## PIC12CE67X Rev. B Silicon Errata Sheet

The PIC12CE67X (Rev. B) parts you have received conform functionally to the Device Data Sheet (**DS30561** and **DS40181A**), except for the anomalies described below.

In the Device Data Sheet (**DS30561B**), the following clarifications and corrections should be noted.

**FIGURE 1: PIC12LCE67X VOLTAGE-FREQUENCY GRAPH,  $-40^{\circ}\text{C} \leq T_A \leq 0^{\circ}\text{C}$**

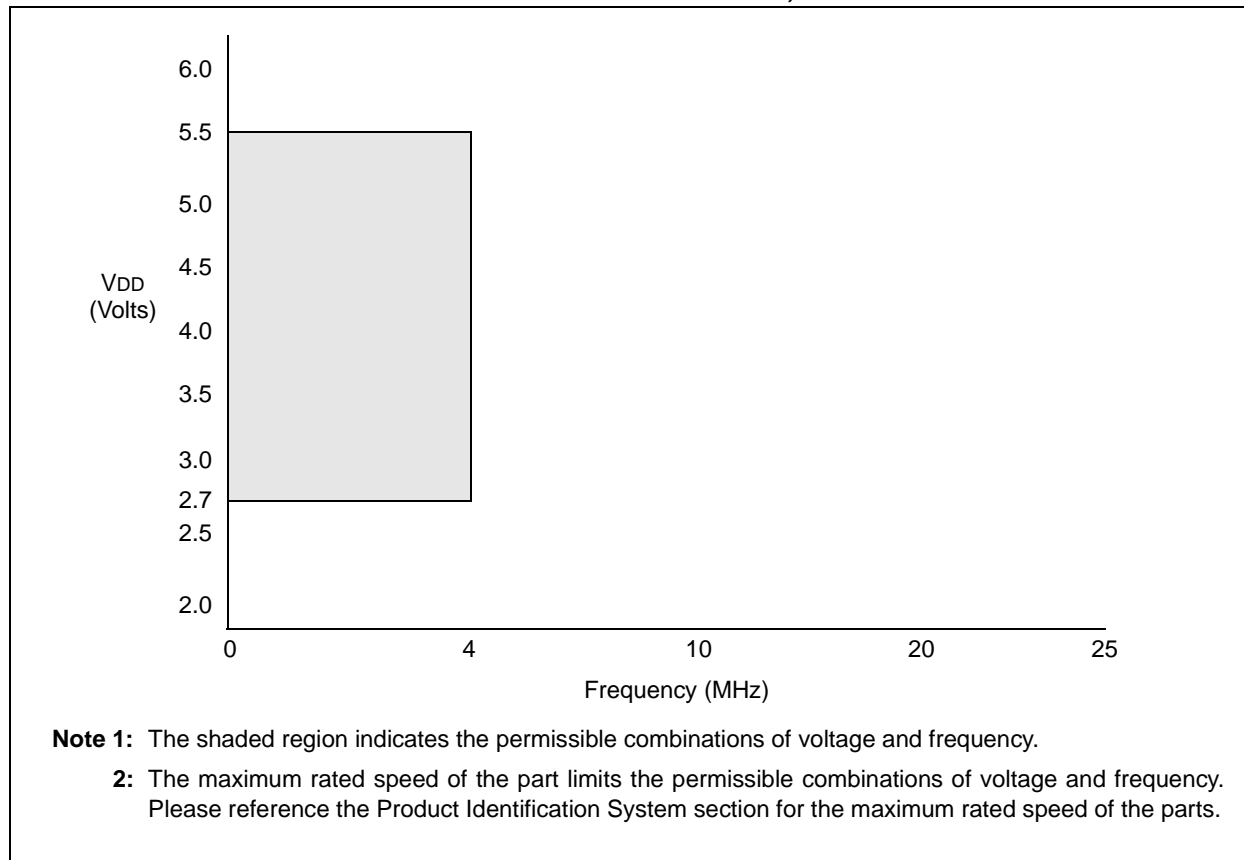
In Section 4.0, corrections for the Special Function Register Summary, Table 4-1, are shown. Correction for the “OSCCAL” Register, Section 4.2.2.7, is shown. Clarification to the “GPIO”, Section 5.1 is provided. Corrections for the Internal 4 MHz RC Oscillator, Section 9.2.5, are shown. Corrections for Section 9.0, Initialization Conditions for all registers, Table 9-7, are shown. Corrections for the DC Characteristics, Sections 12.3 and 12.4 are shown.
